MVP Variance Request Form

A-53

**Mountain Valley Pipeline, LLC
Mountain Valley Pipeline Project
Docket No. CP16-10-000**

**Mountain Valley Pipeline Project
Variance A-53
February 20, 2019**

Mountain Valley Pipeline Variance Survey Exhibit; Variance A-53

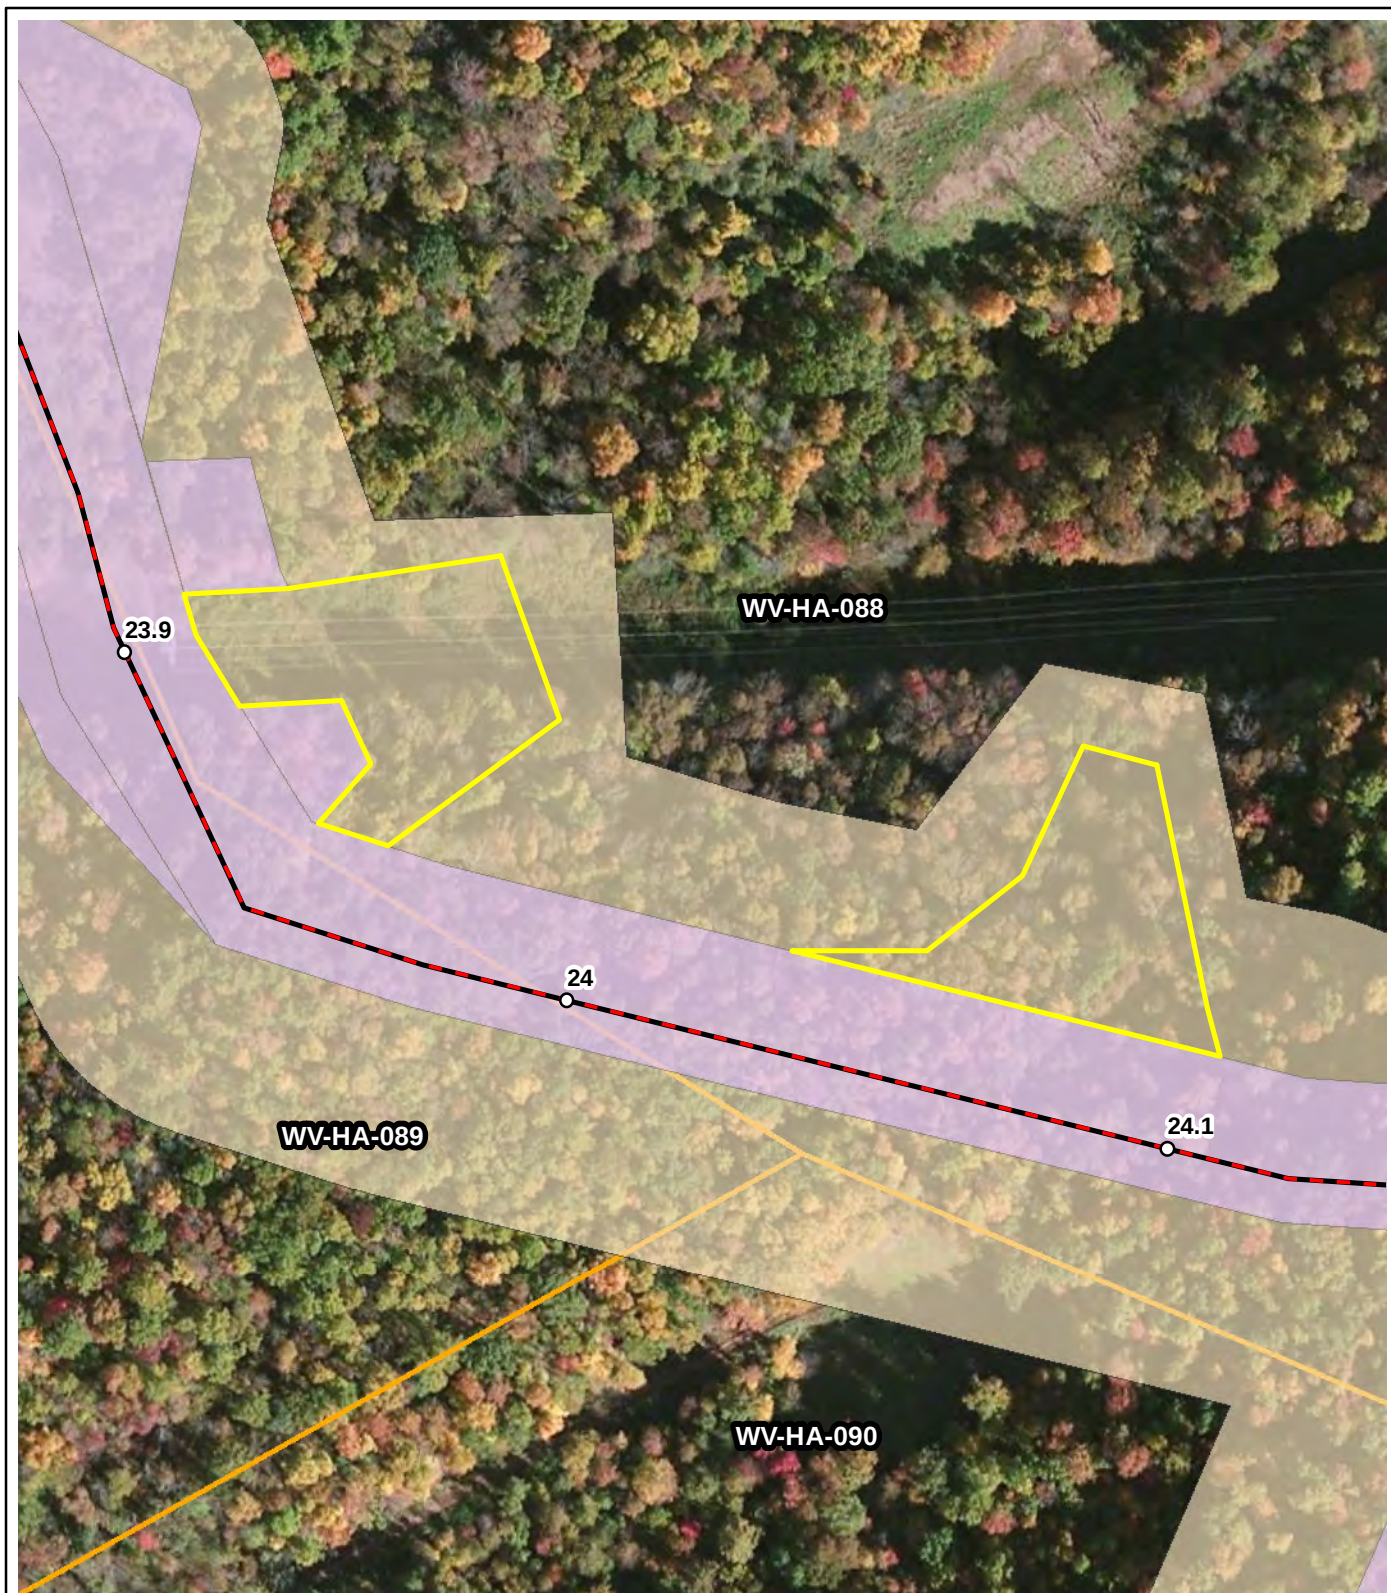
The modification of the tree clearing results in a net increase of 0.10 acres MYSO - Unknown Use Summer Habitat (UUSH). Tree clearing will not occur between June 1st - July 31st and October 1st - November 14th as per the BO. On January 29, 2018 the USFWS concurred with MVP's proposed process for reviewing variances that require tree clearing. Attachment 2 includes a table that shows MVP's acreage "banks" will remain net positive following approval of this variance request.

On 12/12/2014, 11/10/2015, 01/15/2019, and 02/15/2019, Environmental Solutions and Innovations, Inc. (ESI) conducted field surveys to search for portal openings (winter bat habitat). Surveys were conducted in accordance with agency approved protocols for the project. No portal openings were observed in the variance area.

Mountain Valley Pipeline Project		 NAD 1983 UTM 17N 1 inch = 200 feet 
 Proposed Variance A-53 <i>Harrison County, West Virginia</i> March 2019	Legend  Issued for Construction LOD  Proposed Variance Limit of Disturbance  Culvert	
	Data Sources: ESRI Streaming Data 2014.

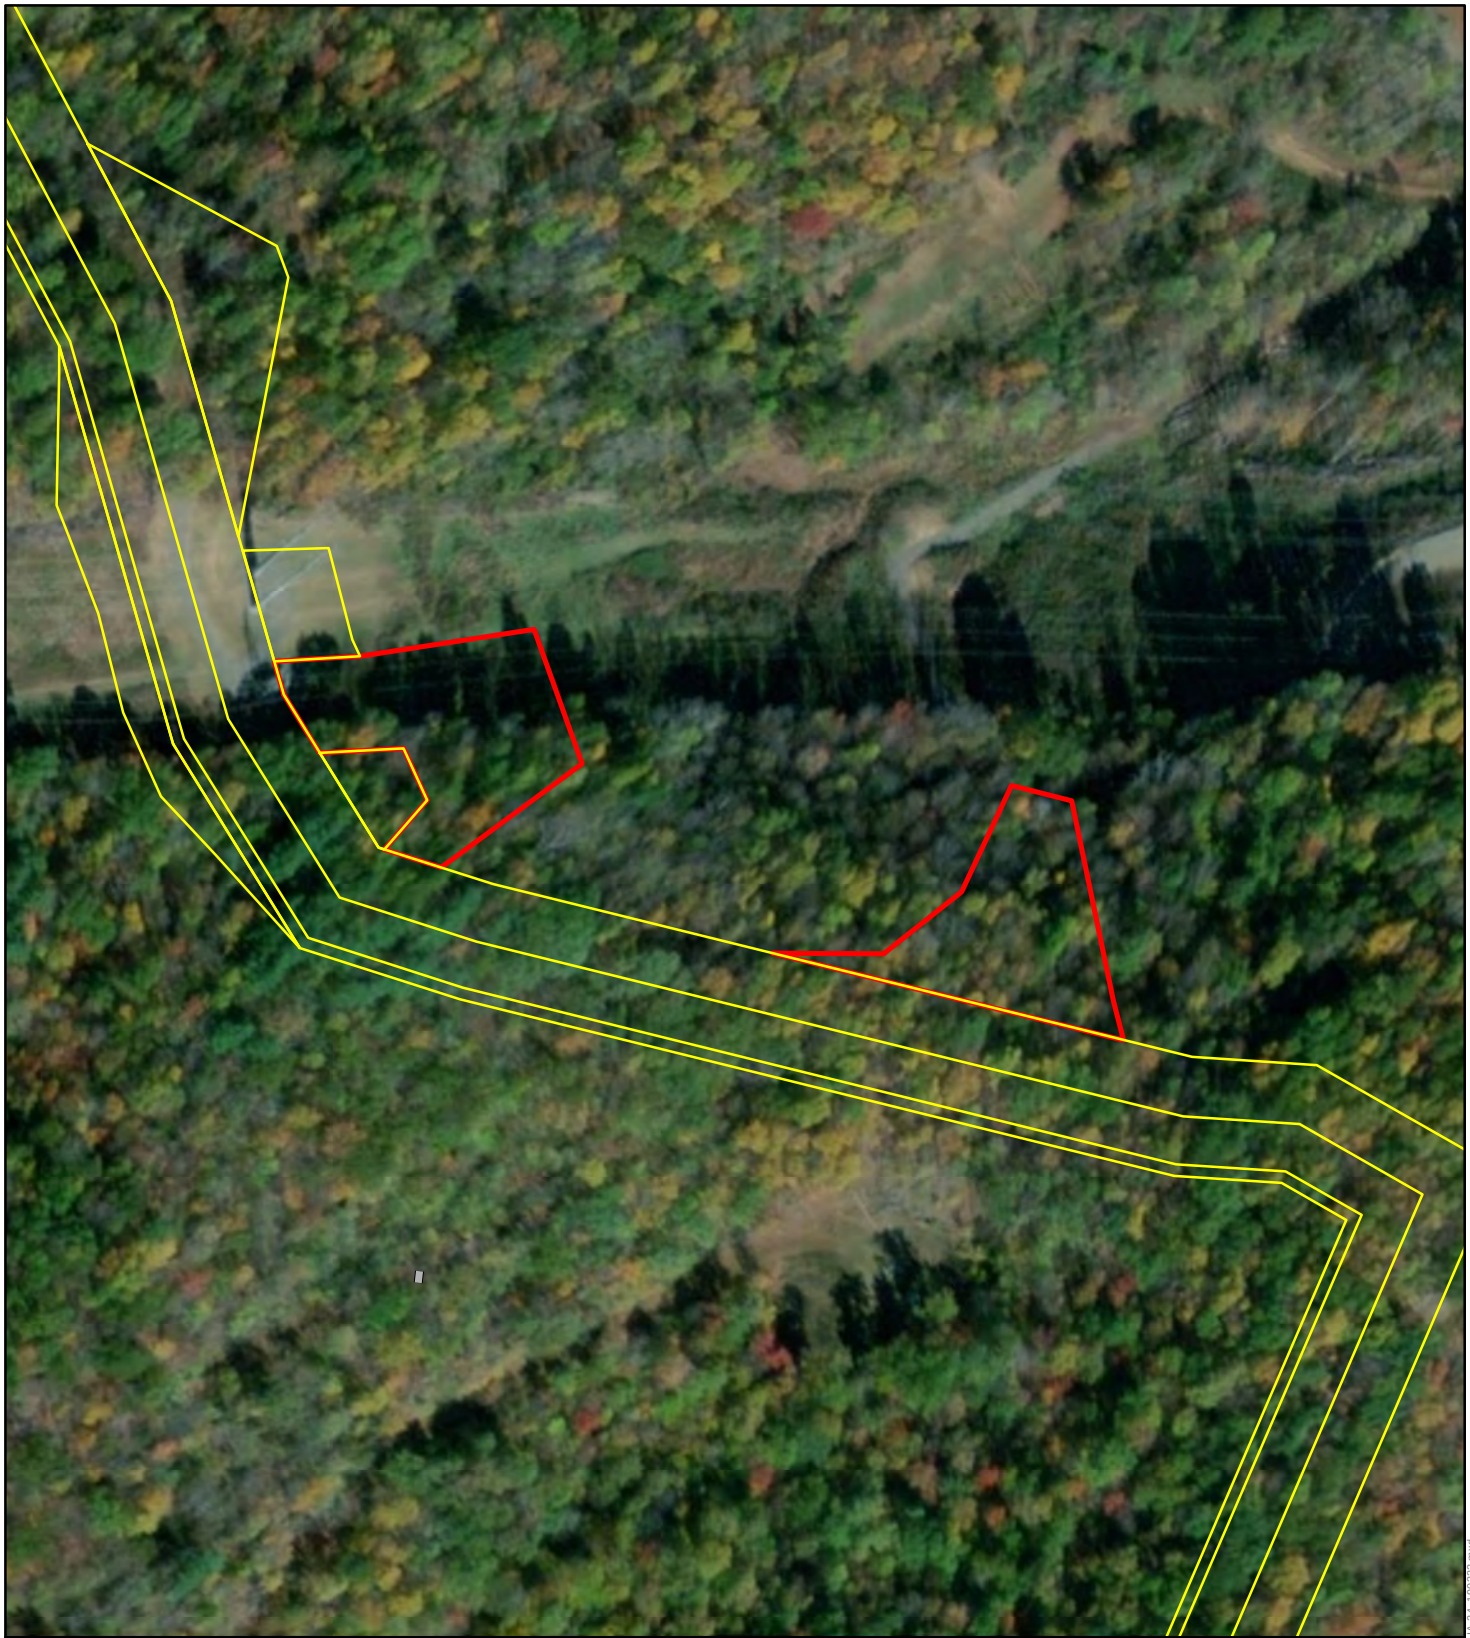
During field surveys, Tetra Tech did not identify any wetlands or streams in the variance area as shown on the attached figure.

**Pipeline Variance
Request Map
Attachment 6**

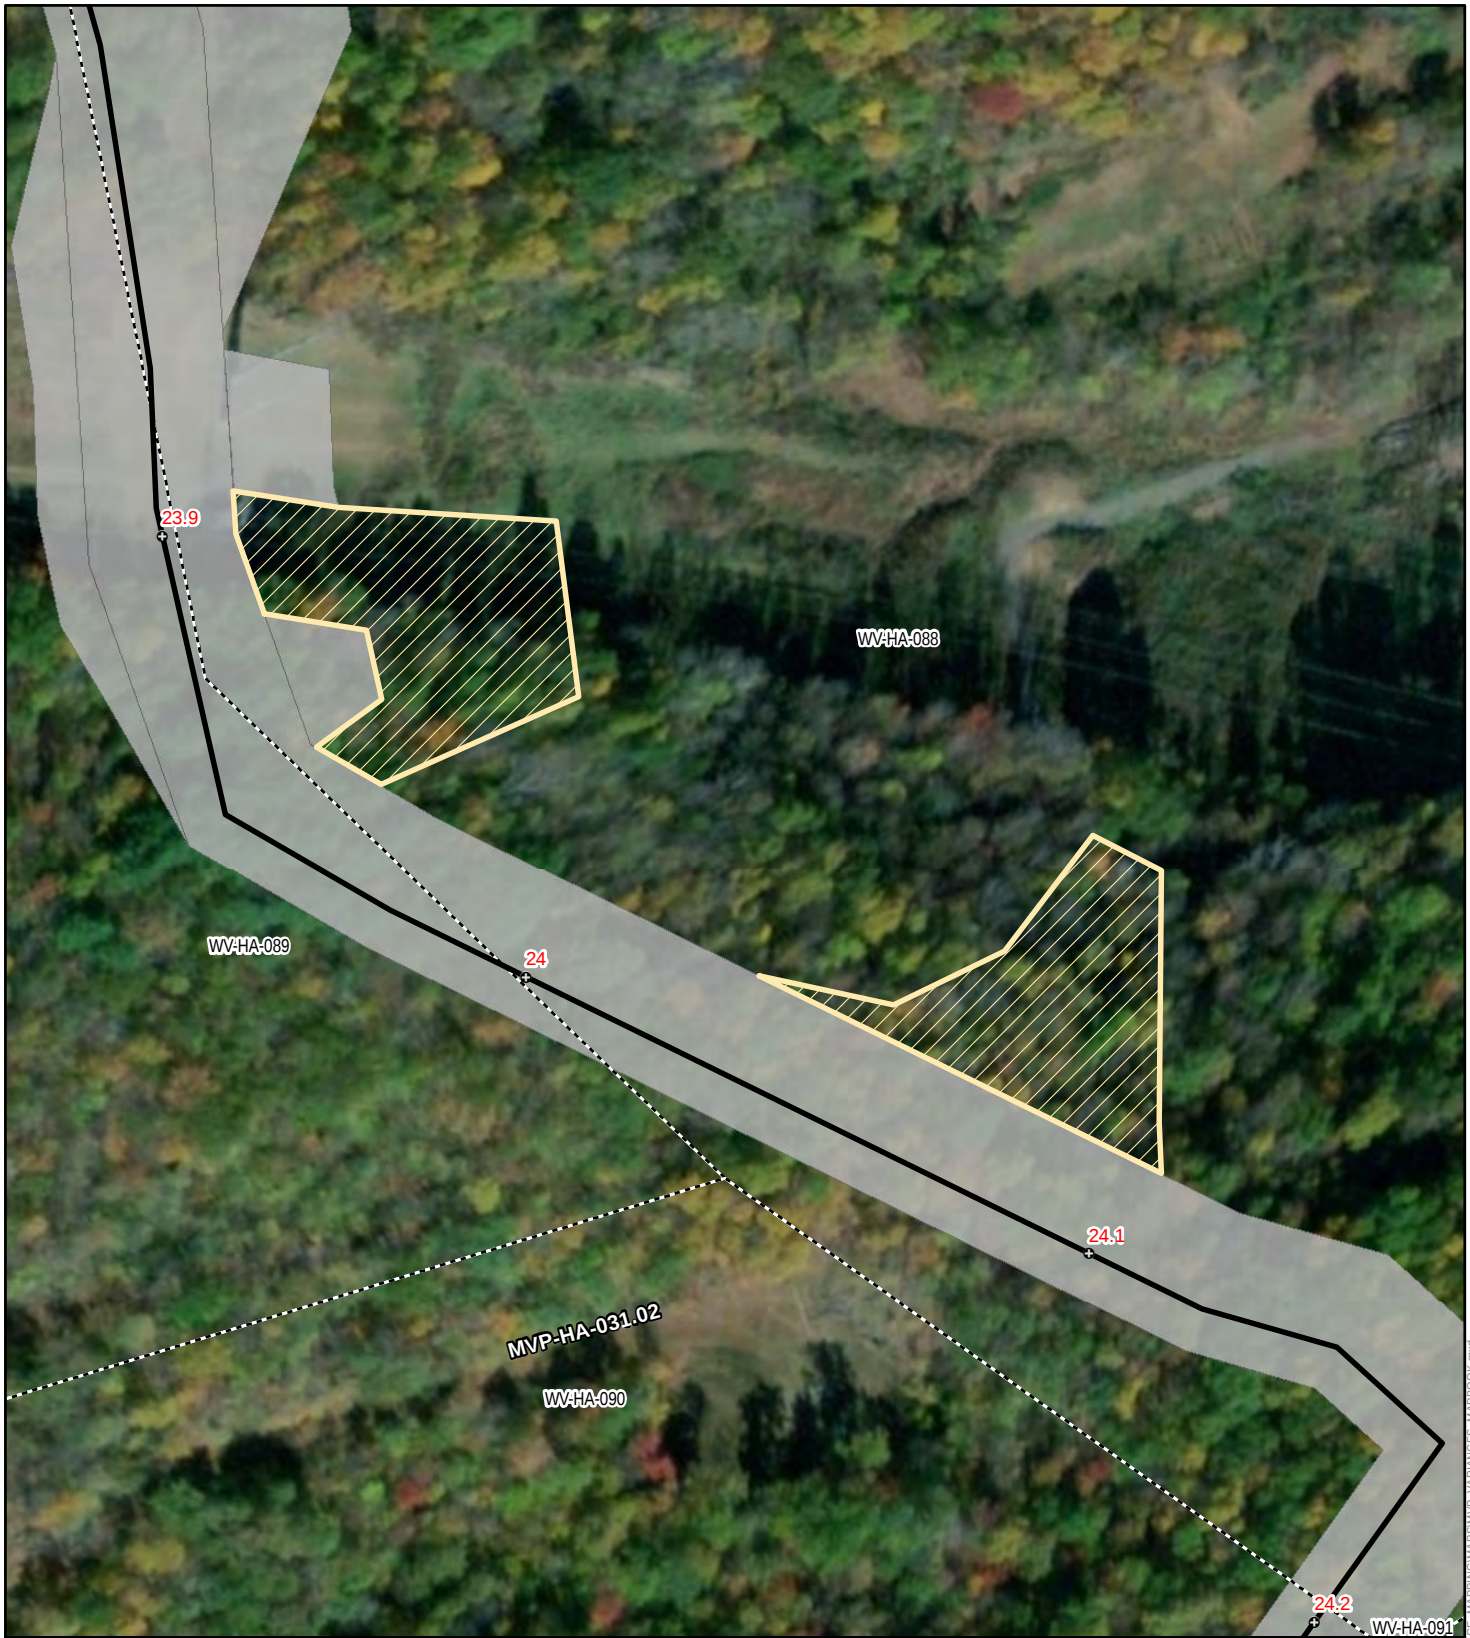
This variance adds MVP-ATWS-SM-055 and MVP-ATWS-SM-048 for slip remediation. No streams or wetlands were found during delineations. Cultural resource 46HS107 was found during surveys. It was deemed Isolate-Not Eligible. Letters of Concurrence can be found in Attachment 4. This variance has a net increase of 1.86 acres of LOD from the original permit. There is a net increase in tree clearing of 0.10 acres of MYSO - Unknown Use Summer Habitat (UUSH). On January 29, 2018 the USFWS concurred with MVP's proposed process for reviewing variances that require tree clearing. Attachment 2 includes a table that shows MVP's acreage "banks" will remain net positive following approval of this variance request. Tree clearing is permitted in this area prior to June 1, 2019.
